Event # 45105

PART 21 FOR MISSING PARTS ON ASCO SOLENOID VALVES

Subject – Missing insulating barrier and label on two (2) ASCO NPEFKX8300141EG  
10688 125/DC solenoid valves

Figure 1.

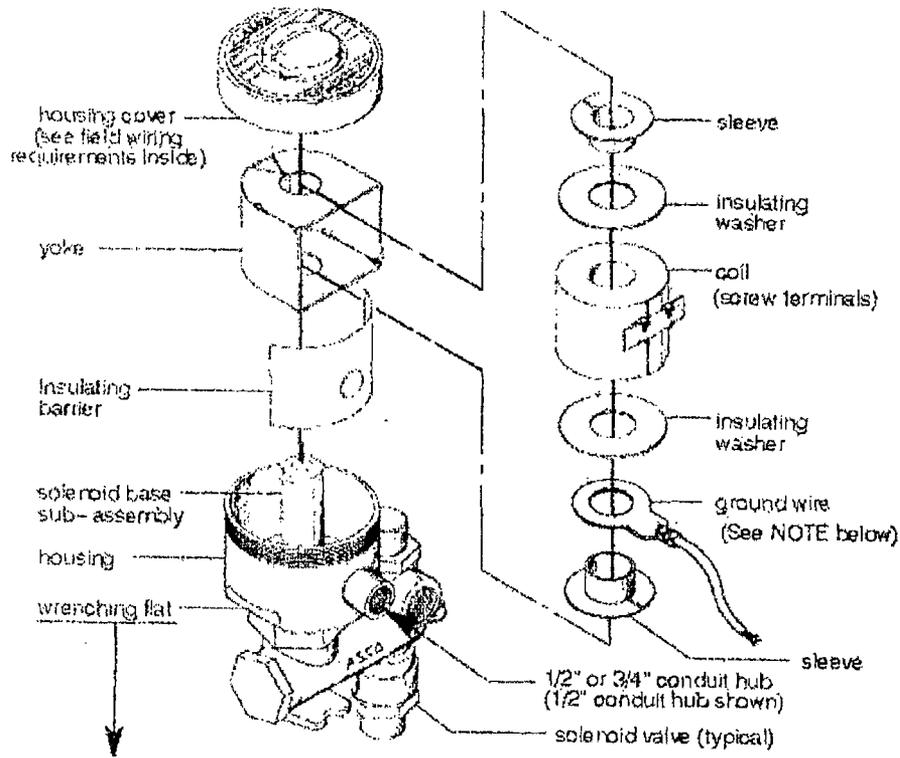
**Background-** On 4/24/09 ASCO Engineering was made aware of a non-conformance in the valve assembly area. During the assembly of a solenoid valve, part number NPEFKX8300141EG 10688 125/DC, the valve assembler noticed that the valve was missing an insulating barrier. Ref Fig 1. Engineering reviewed the bill of materials (BOM) for the valve and confirmed that the insulating barrier (p/n 032818-004) was not listed on the BOM. In addition a wiring label (p/n 230195-001) used with screw terminal coils was also not included in the BOM.

**Impact on Performance** – The insulating barrier is used on ASCO valves supplied with screw terminal coils. The barrier provides an electrical insulation between the screw terminals of the coil and the metallic solenoid housing. The screw terminals of the coil are intended to serve as junction point for the field wire and the coil. If the screw terminals were to come in contact with the housing while the valve was energized there would be an electrical short resulting in a breaker / fuse trip. This would interrupt power being supplied to the valve and the valve would shift to the de-energized position.

**Corrective Action** – Dominion Virginia Power – North Anna advised that one of the valves had been installed and one was still in their stock room area. The valve in the stock room was evaluated and confirmed to be missing the barrier. This valve is being returned and will be repaired at ASCO. Dominion Virginia Power – North Anna indicated that the installed valve will be evaluated during an upcoming outage. ASCO has recommended that a repair kit be installed at which time the barrier and wire label can be properly installed.

ASCO determined that the barrier was missing from the valve because it was not listed on the BOM and not supplied with the valve during assembly. Further investigation identified that when the valve components were being selected, the engineer modeled the BOM based on a design that does not use the barrier and label. In order to prevent future occurrences, ASCO has added a secondary verification whenever BOMs for new valves are created in order to verify that the correct parts have been selected.
